To: Mr. Tim Johnson, American TCB
From: David Waitt, Airespace
Subject: Inquiries regarding Certification application for FCC ID **QTZVAP1200**
Date: 1 April 2003

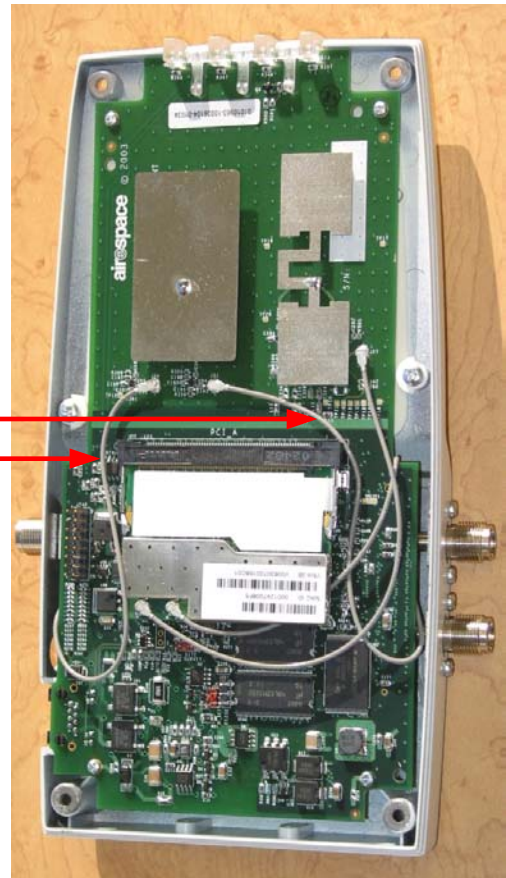
ATCB 4) This submittal appears to contain information regarding external antennas. However, it is not certain how the external antennas connect internally to the device. Please explain and provide photographs as necessary.

Airespace: The reverse TNC connectors used to support the use of external 2.4GHz antennas are connected to the main circuit board in the radio via short coaxial cables shown in the photos below. Note that the hardware is in place to support external 5 GHz antennas; however the configuration software does not support use of external 5 GHz antennas. Currently, until authorized by the commission, configuring the radio to operate with external 5GHz antennas is not possible. The photos on the next page illustrate the internal cables.

These cables connect the main PCB to the external 2.4 GHz antenna connectors

Cables used to connect the main PCB to the 2.4 GHz external antennas connectors

5GHz external antenna connector, in place, but not supported by the configuration software.
